ORANGE AND ROCKLAND UTILITIES, INC.

DEPRECIATION PANEL  
UPDATE/REBUTTAL - ELECTRIC & GAS

**Figure 1: 75-R1 Survivor Curve**

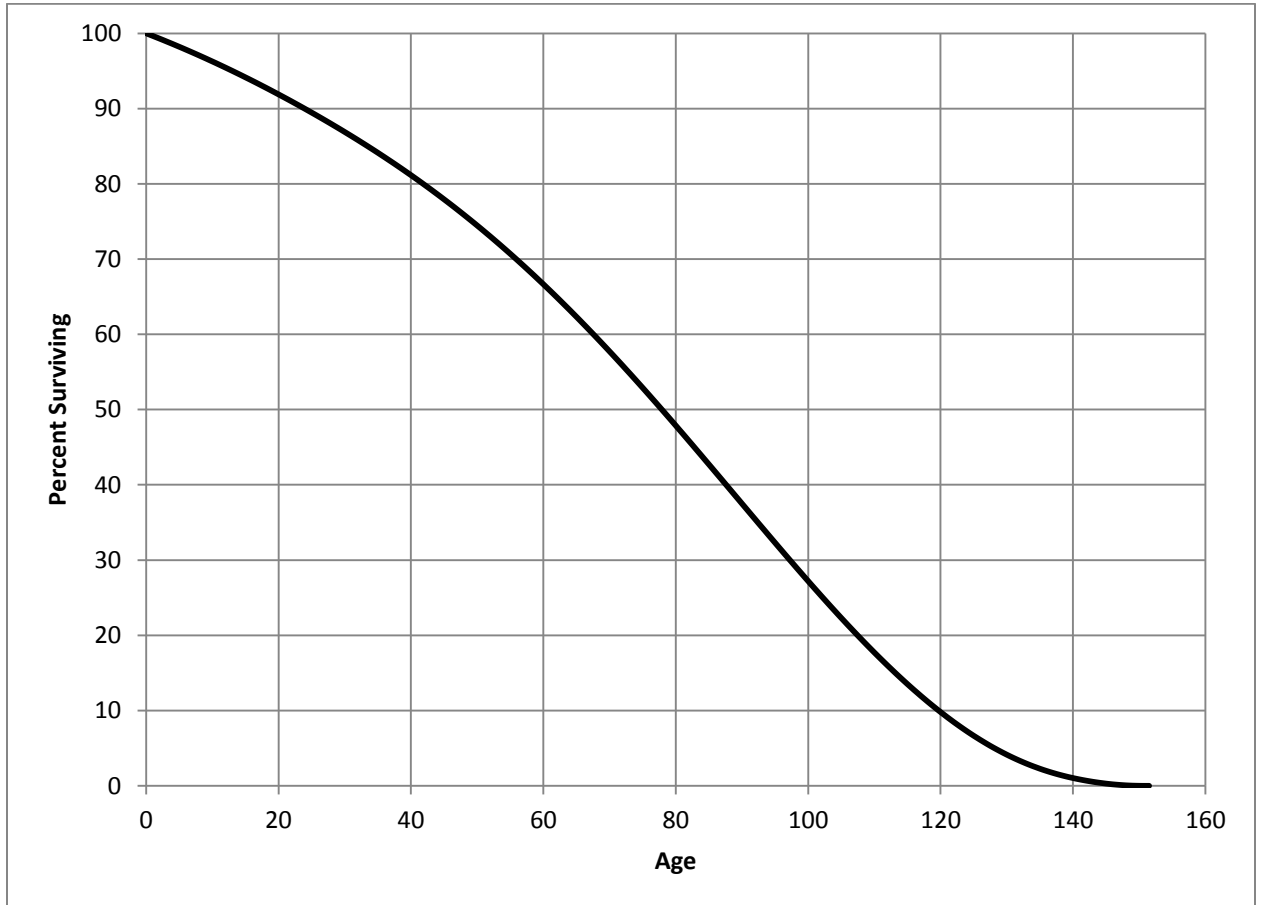
5 A. In our view, the SDP did not give adequate  
6 consideration to the factors discussed above. The  
7 result is a service life estimate that is too long for  
8 the property studied. A graph of the survivor curve  
9 chosen by Staff provides evidence that Staff's  
10 estimate of a 75-R1 estimate for this account is not  
11 reasonable. Figure 1 below shows a graph of the 75-R1  
12 survivor curve chosen by Staff for overhead conductors  
13 and devices.

4 Figure 1 shows the percent of plant that is expected  
5 to last to each age. For example, approximately 80%  
6 of plant would be expected to last until age 40 and  
7 slightly more than 60% would be expected to last until  
8 age 60.

As Figure 1 shows, Staff's estimate predicts that  
approximately half of the Company's assets in this

1 account will last more than 75 years and more than a  
2 quarter of the assets will last over 100 years.  
3 Staff's estimate further predicts that about 10% of  
4 the account will last for 120 years, and a portion  
5 will last longer than 140 years. These expectations  
6 implied by Staff's estimates are not realistic. As  
7 discussed previously, the representative data points  
8 from the original life table for this account do not  
9 reach 50% surviving. Thus, Staff's estimate of these  
10 very long service lives for a significant portion of  
11 the account are based solely on the forecast made by  
12 Staff's estimate - they are not based on the Company's  
13 actual experience.

1 the 65-R1.5 survivor curve has been recommended in the  
2 depreciation study.
